TO: Design Review Commission
FROM: Sean K. Gallegos, Assistant Planner
SUBJECT: 13-SC-33 – 1650 Morton Avenue

Approve design review application 13-SC-33 subject to the listed findings and conditions

This is a design review application for a new two-story, single-family house. The proposed project will demolish an existing one-story house and accessory structure and construct a new house with 2,289 square feet on the first story and 1,261 square feet on the second story. The following table summarizes the project:

Appendix A: Protection Map

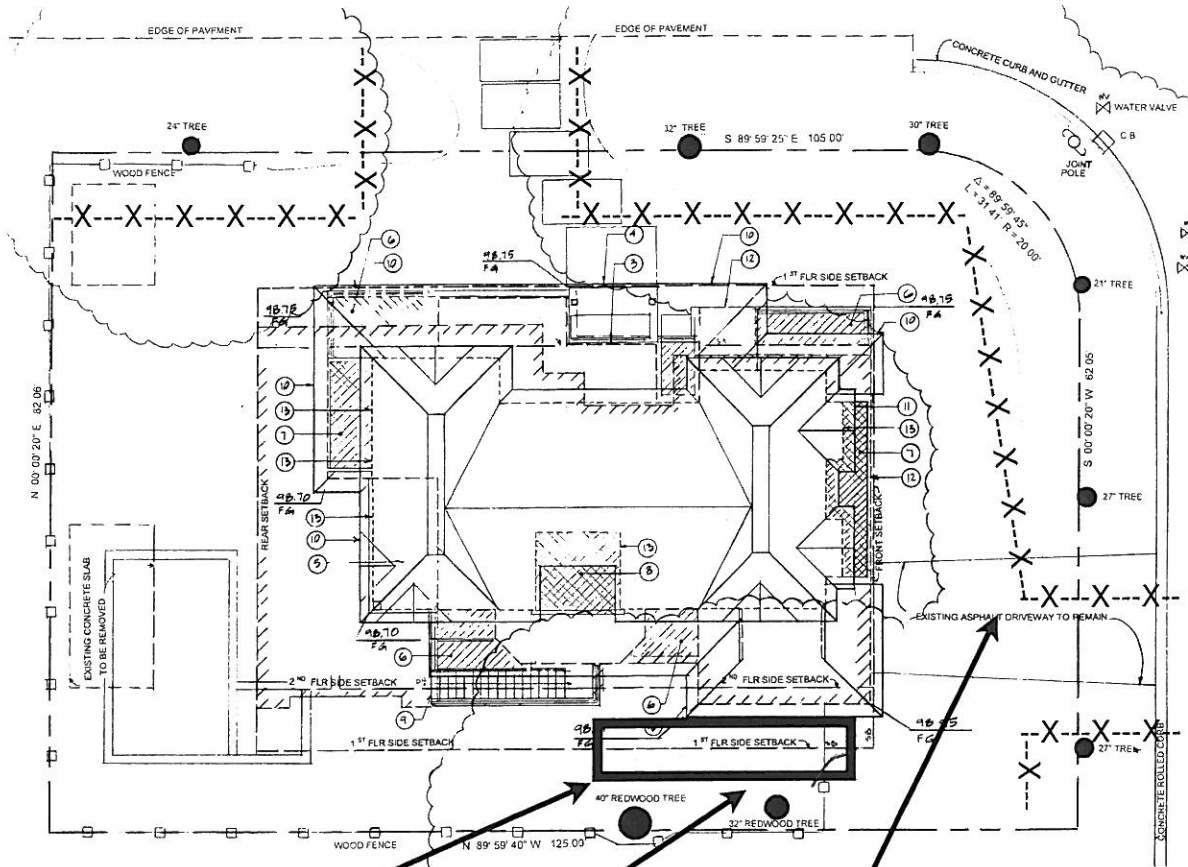
Bridge with mulch or timbers and plywood or road plate near the coast redwoods.

Place tree protection fencing 13 feet from the trunks or at edge of pavement.
